WIRELESS STATION A510

TECHNICAL HANDBOOK - MODIFICATION INSTRUCTION

Receiver netting

Increasing keying speed

Fig 1 - Underside view of receiver chassis

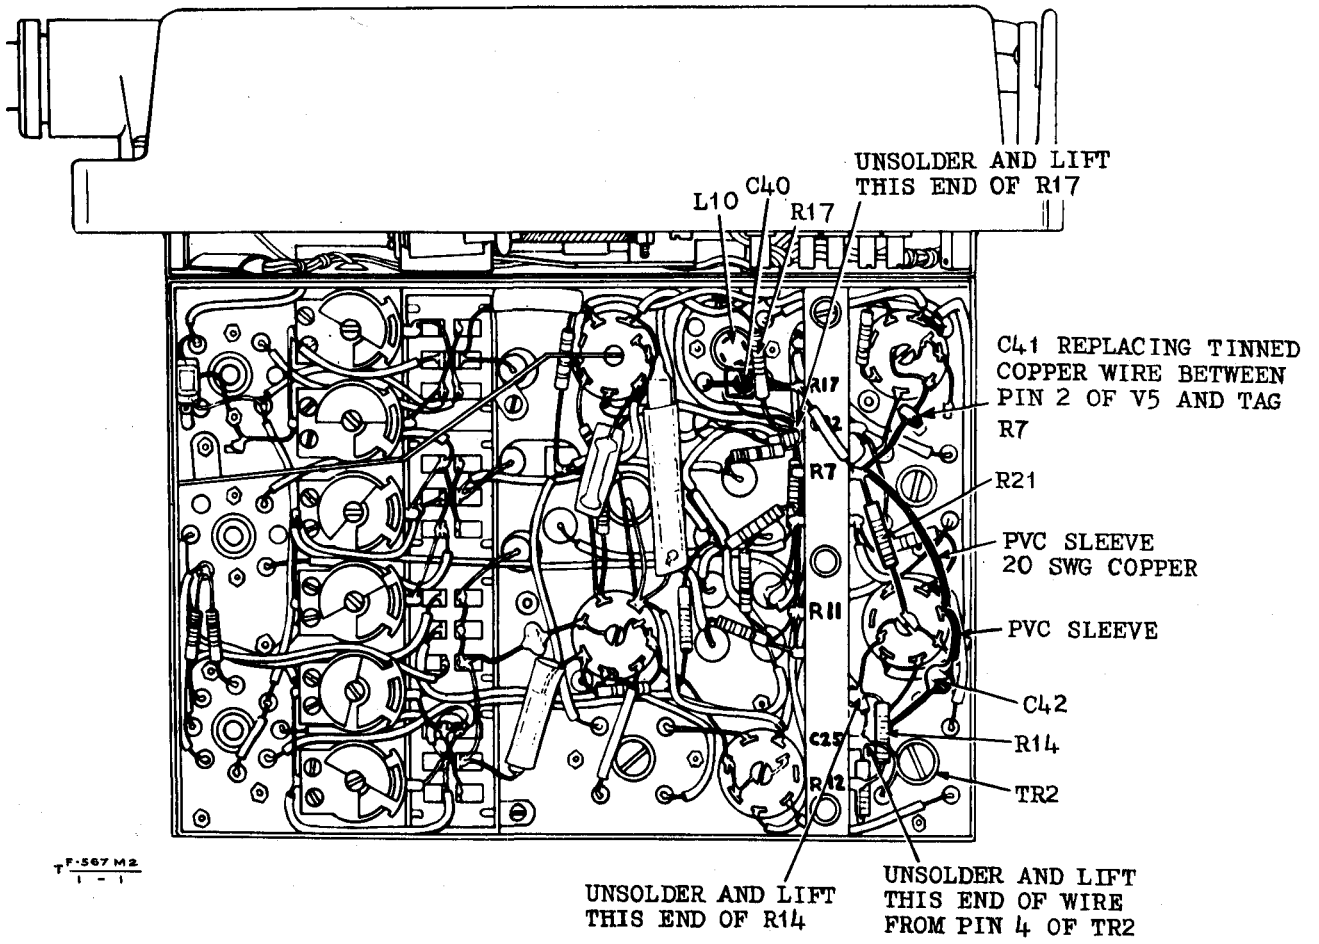
1. This modification has been introduced in order to improve the netting of the receiver by reducing the spurious responses. Additional bias is applied to the detector diode during netting.

- (b) Locate resistor R17 ($47k\Omega$ $1/2W$) and unsolder and lift that end of it which is connected to the tag marked 'C32'.
- (c) Cover the body of one of the Capacitors, Z/ZA 1756 supplied, with $3/8$ in. of 10 mm P.V.C. sleeving and solder this capacitor between pin 1 (green spot) of the inductor L10 and the tag marked 'R17'. This capacitor becomes 'C40'.

- (f) Solder the other Capacitor Z/ZA 1756 in circuit between the two points from which the wire was removed at 7(e), ie between pin 2 of V5 and the tag marked 'R7'. This capacitor becomes 'C41'.

- (g) Solder the resistor Z/Z 222130, supplied, between the tag marked 'R7' and the centre spigot of the valve holder V4. This resistor becomes 'R21'.
- (h) Connect the tag marked 'R7' to pin 4 of the valve holder V4 using 20 s.w.g. tinned copper wire insulated by $1.1/2$ mm yellow P.V.C. sleeving.

- (k) Connect the Capacitor Z/AZ 1761, $4.7pF$, supplied, between pin 4 of the valve-holder V4 (covering this lead of the capacitor with $1.1/2$ mm yellow P.V.C. sleeving) and pin 1 (red spot) of TR2. This capacitor becomes 'C42'.

Fig 1 - Location of C109

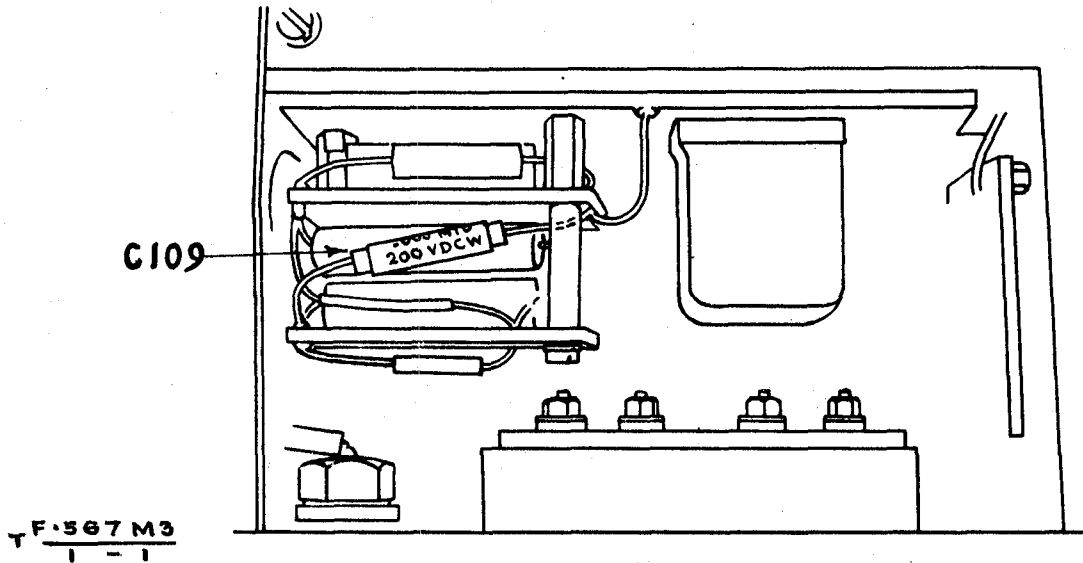
- (b) Locate capacitor C109 (0.001 μ F) (see Fig 1).
- (c) Replace C109 by one of the 0.005 μ F capacitors (Z/Z 115626) provided, connecting one end of the new capacitor to the earth point directly below the spacing pillar and the other end to the top tag diagonally opposite to this earth point. Discard the 0.001 μ F capacitor.

Fig 2 - Location of C111 and C127

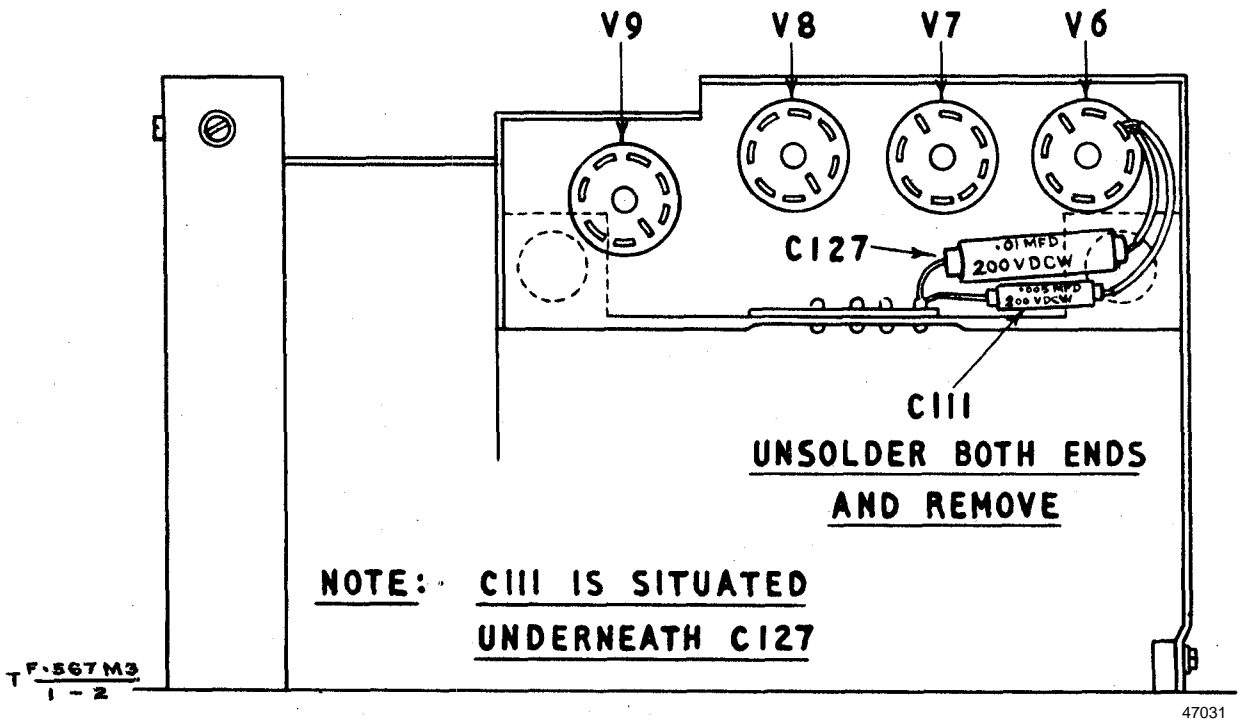
- (d) Locate and remove capacitor C111 (0.005 μ F), which is connected between pin 2 of the valve holder V6 and the terminal plate, and lies underneath capacitor C127 (0.01 μ F) (see Fig 2). Discard the capacitor.

Fig 3 - Capacitor C129 in position

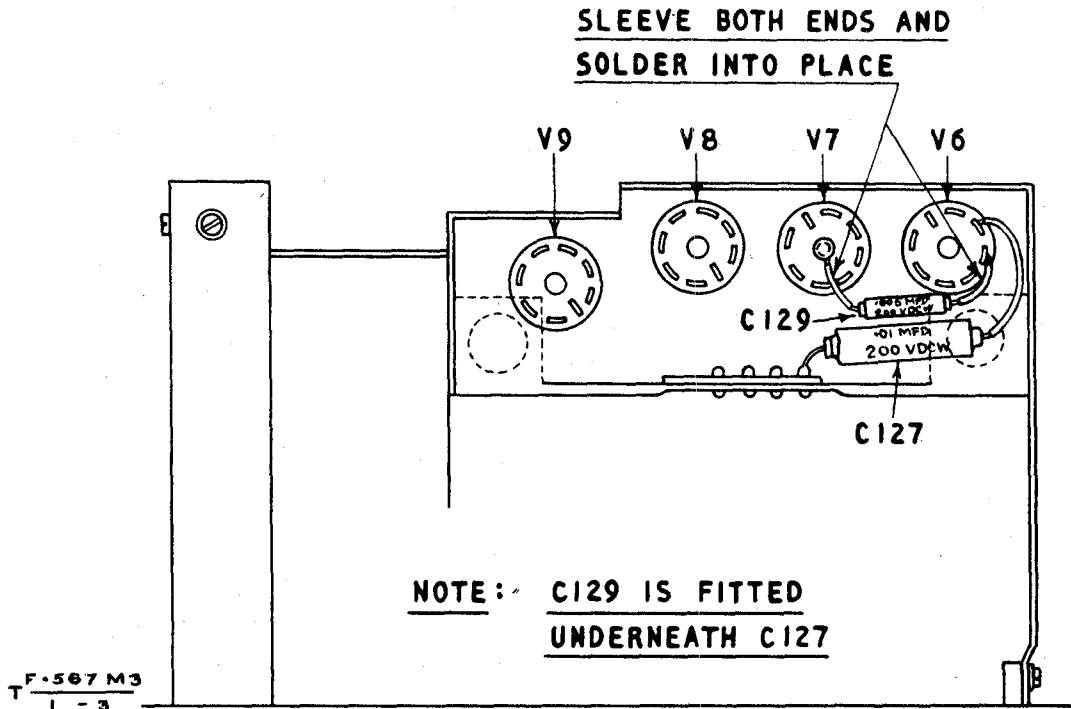
- (e) Place the other capacitor Z/Z 115626 supplied, into the space vacated by C111 and connect it between pin 3 of the valve holder V6 and the earthed spigot of the valve holder V7, after cutting each of the leads of the new capacitor to a suitable length and insulating it with 1.1/2 mm yellow sleeving. This new capacitor becomes 'C129' (see Fig 3).

Fig 4 - Resistor R117 in position

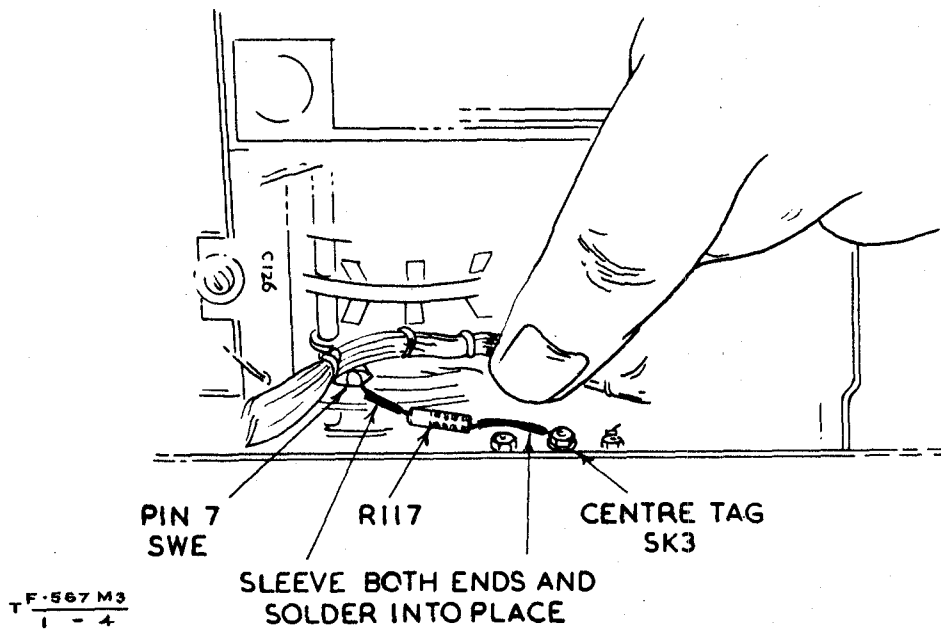
- (f) Referring to Fig 4, locate and remove the lead which joins the centre tag of the 3-point key socket SK3 to pin 7 of the switch SWE. Solder the resistor (220k Ω , Z/Z 223079) supplied, between the same two points ie so that it takes the place of the lead removed. The new resistor becomes R117.
